LU 2021-023 SUB Cedar Creek Gardens

Week 2 Rebuttal Period

Exhibit C – Public Testimony

Addendum to Sweeney Argument #1

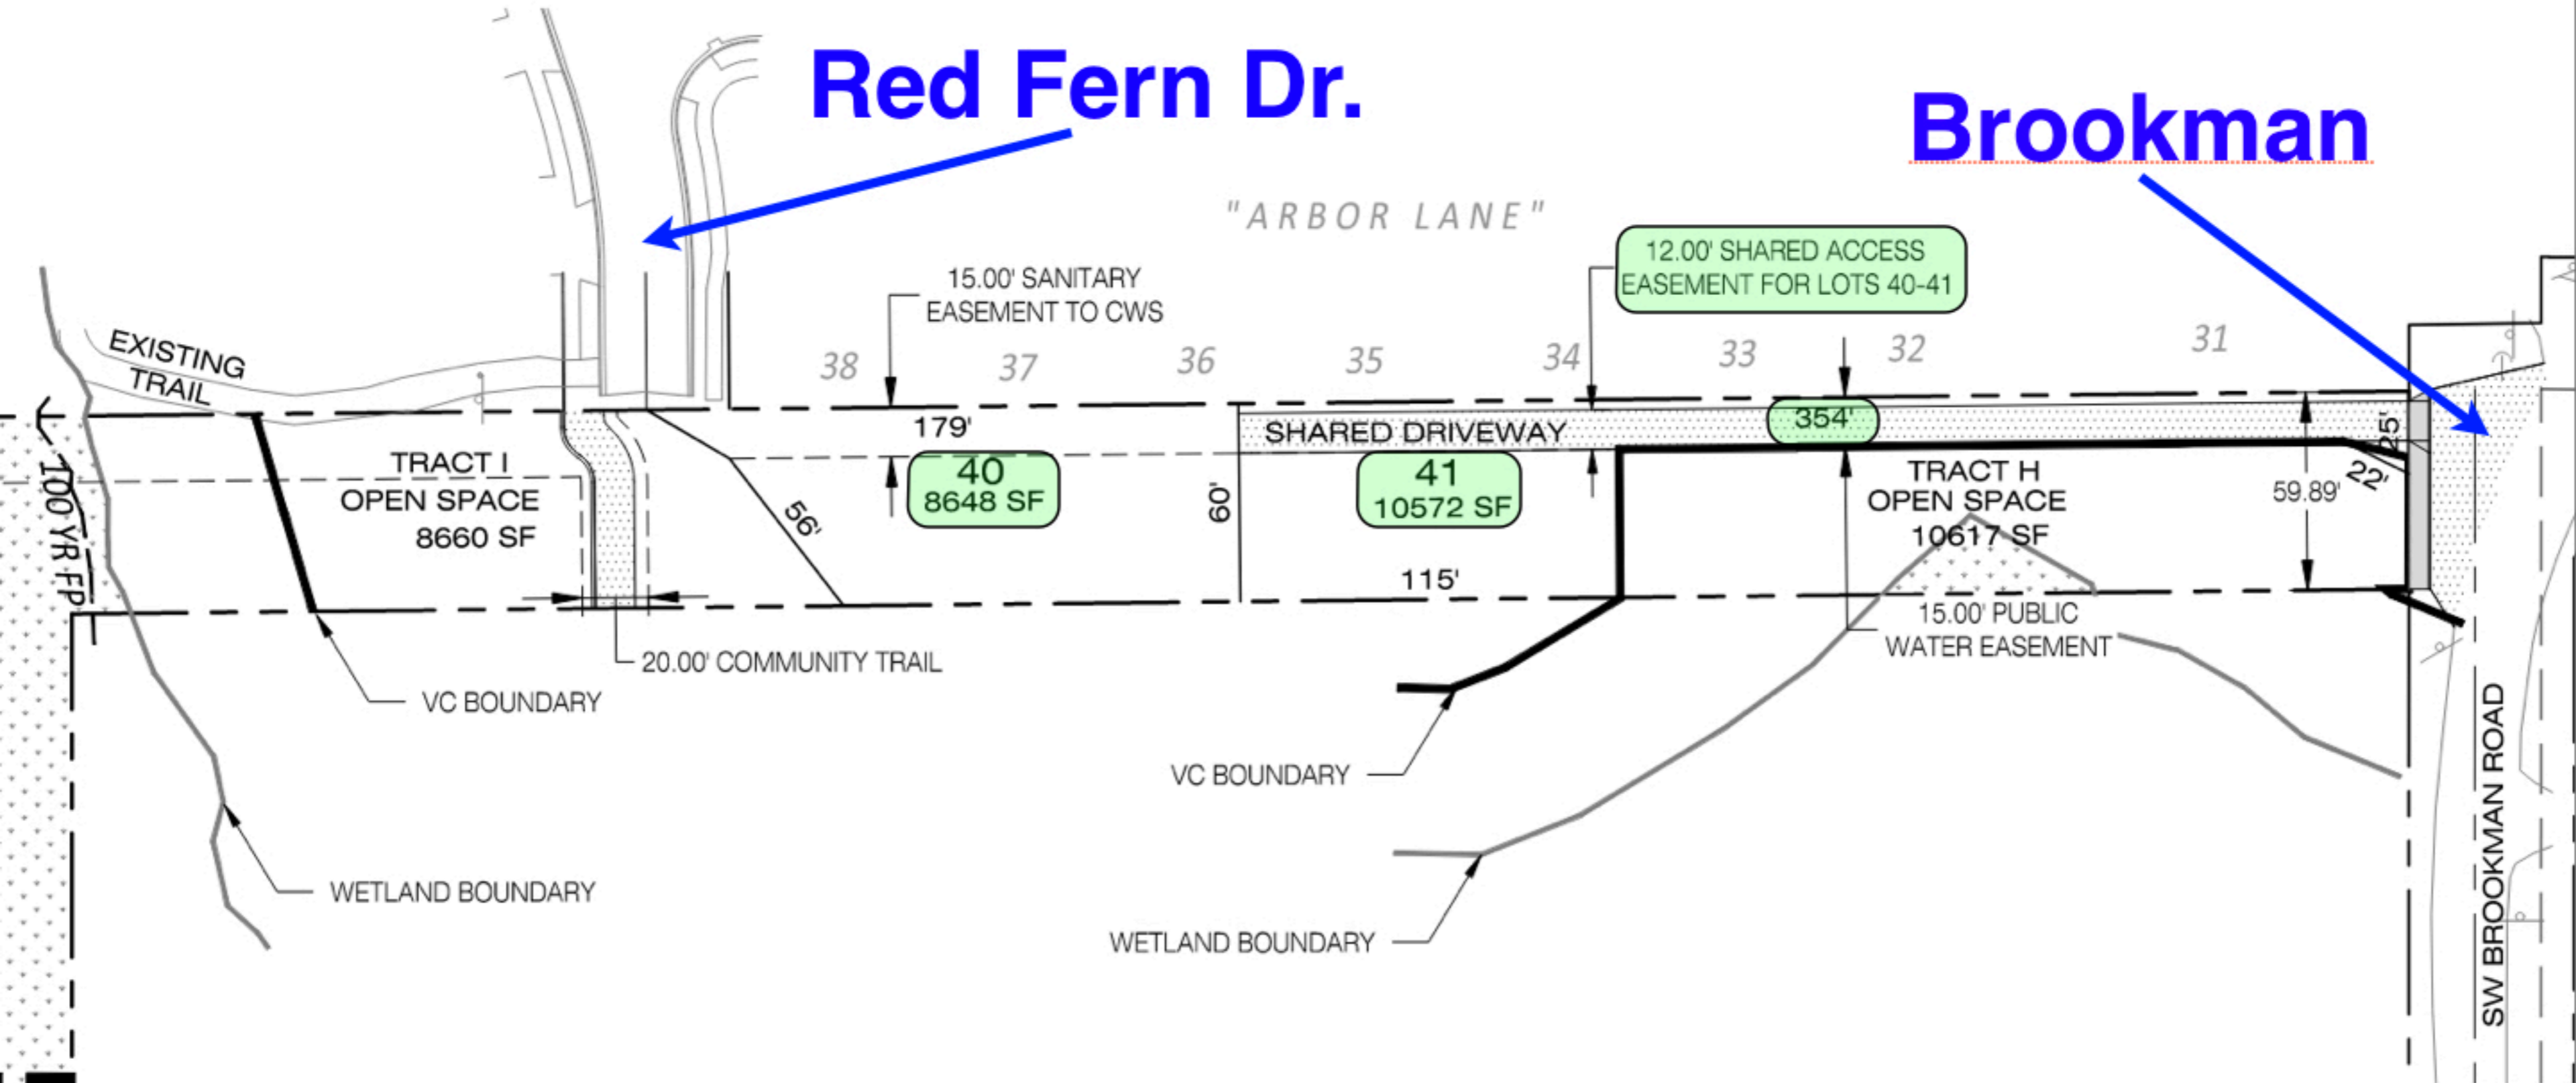
The addendum to this argument comes in the form of supportive information (aka Maps #s 5, 7, 14, & 28). All four are of a twenty (20) foot width of a private street. Map #7 the 20 foot width of the private street serving lots 19 & 20, Map #14 the 20 foot width for private street serving lot 39. Map #28 serving the private street for lots 2 & 3 is not *exactly* labeled as 20 feet in width but *is* labeled with something a little less than 25 feet (see green blob to the right of lot #1). And map #5 showing the shared driveway serving lots 40 & 41 only 12 feet wide.

#5

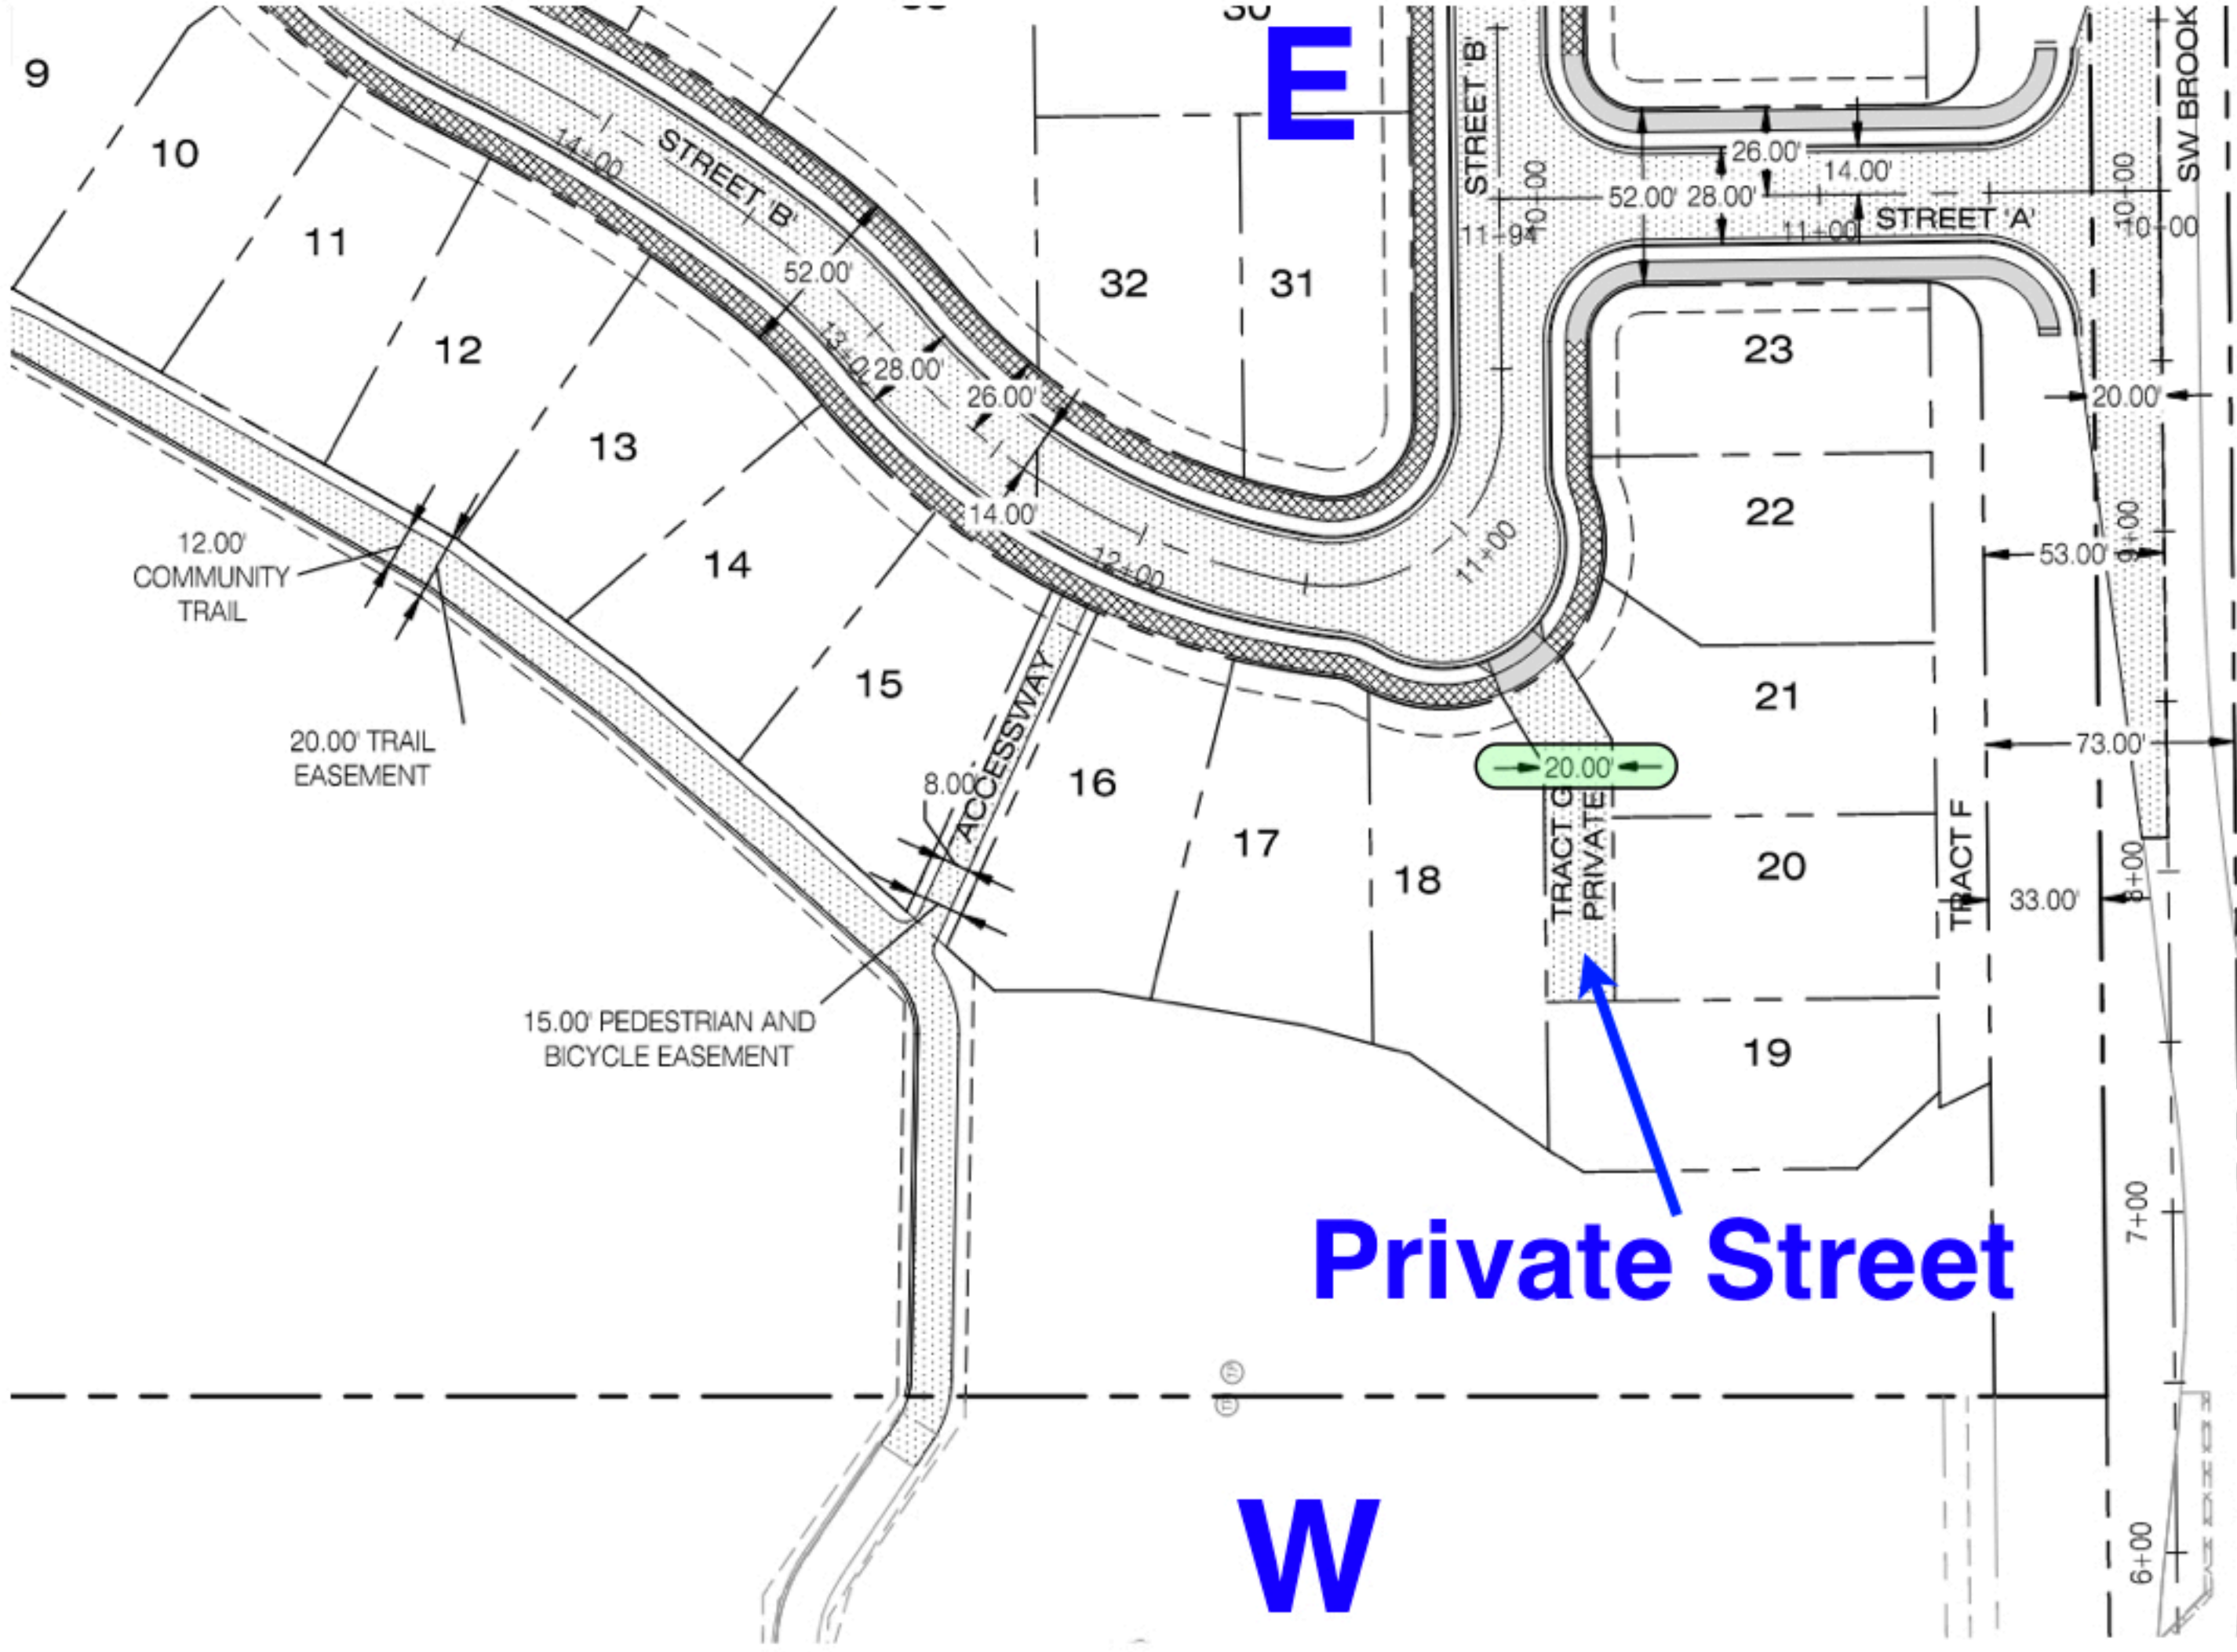
The shared driveway (aka private street) in the flagpole section that serves lots 40 & 41 has a width of twelve (12) feet (see Map #5). The code (above) specifies that the minimum width (my underlining) for a two-family driveway should be twenty (20) feet.

#7

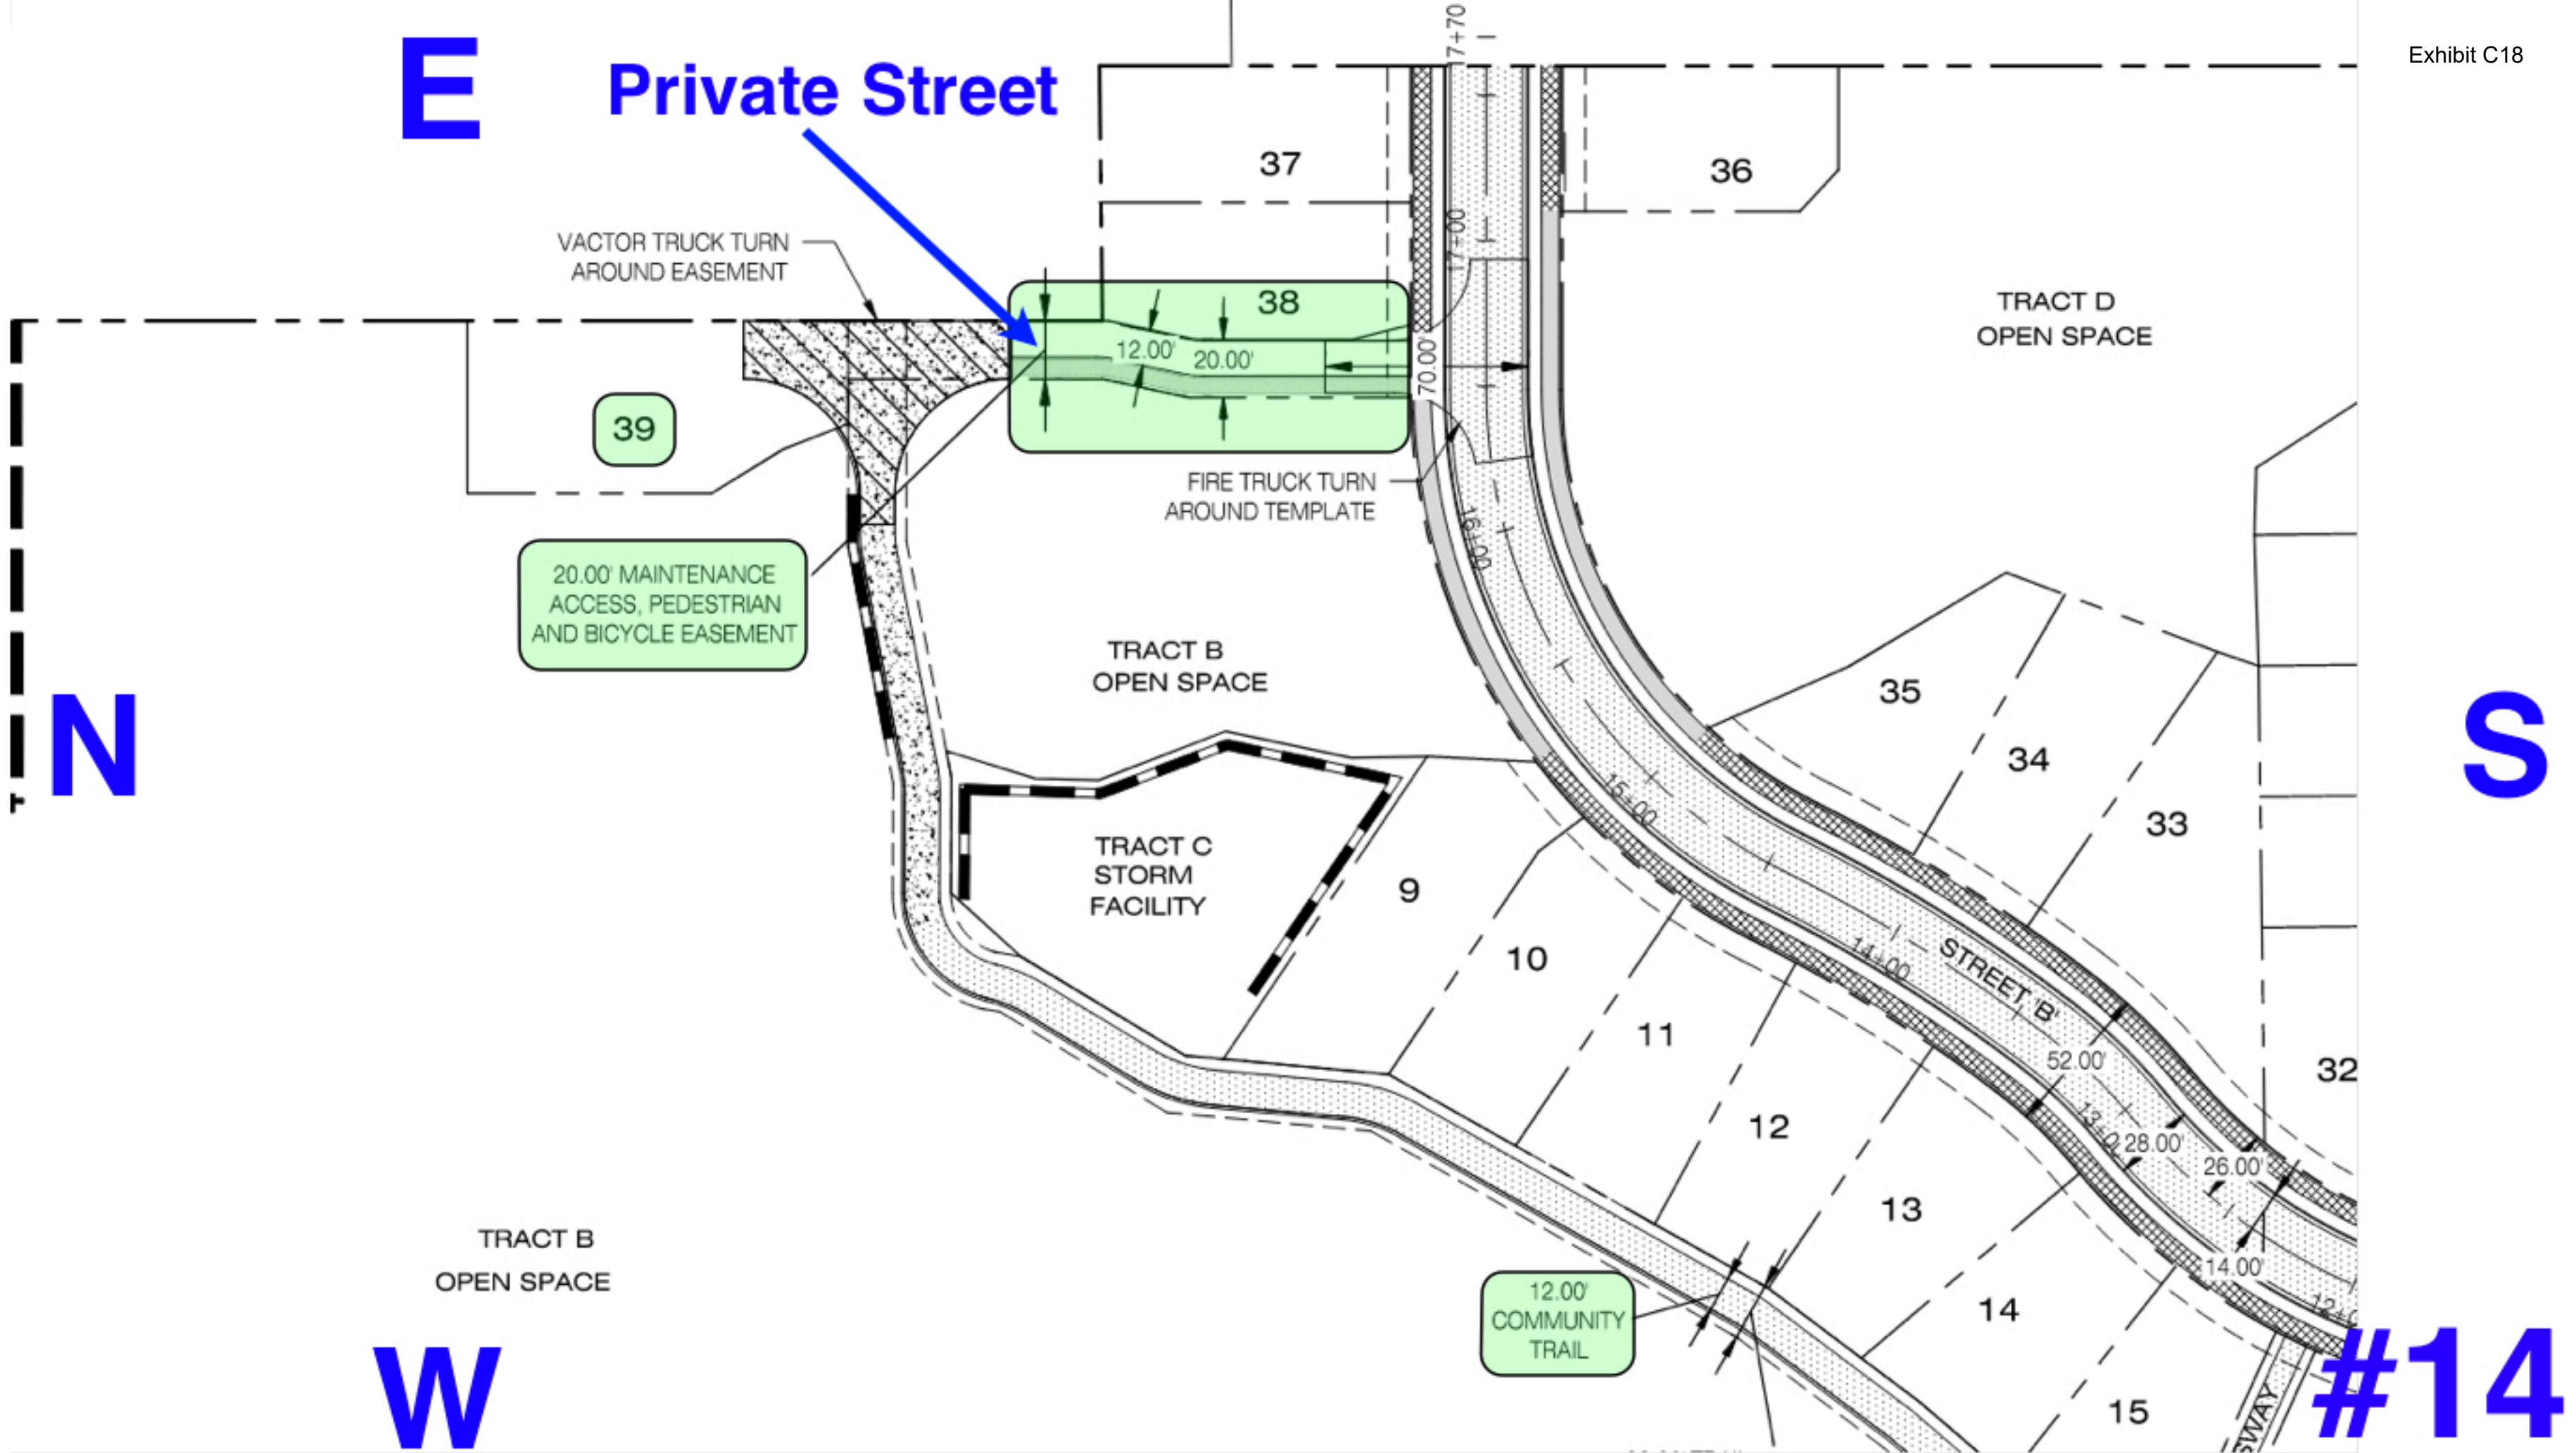
Since three of the private streets (serving lots 2 & 3, 19 & 20, and 39) are 20 feet in width it supports the 20 foot wide shared driveway for two families and lots 40 & 41 and Section 16.96.020.A.2. of the Code:
